J2127A-07

SERVICE NOTE

AGILENT J2127A Transmission Test Set

Possible damage tracks caused by wrongly fitted stand-off.

Figure 1 Location of the Polycarbonate Squares

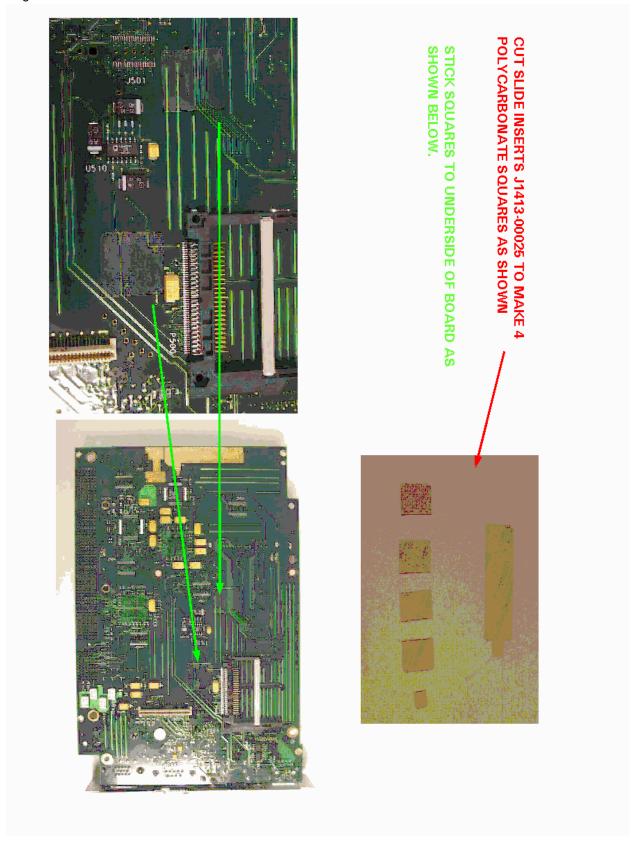
Due to a design problem on the Control Assembly (J1413-65001), a stand-off has been fitted the over tracks on the Processor Assembly (J1413-65002). Vibration may cause the stand-off to damage the tracks (which go to the flash card) and this may cause the instrument to fail on boot-up.

The Control Assembly should be dismantled and the affected tracks on the Processor Assembly should be protected with polycarbonate tape. Refer to Figure 1 for the location of the polycarbonate tape.
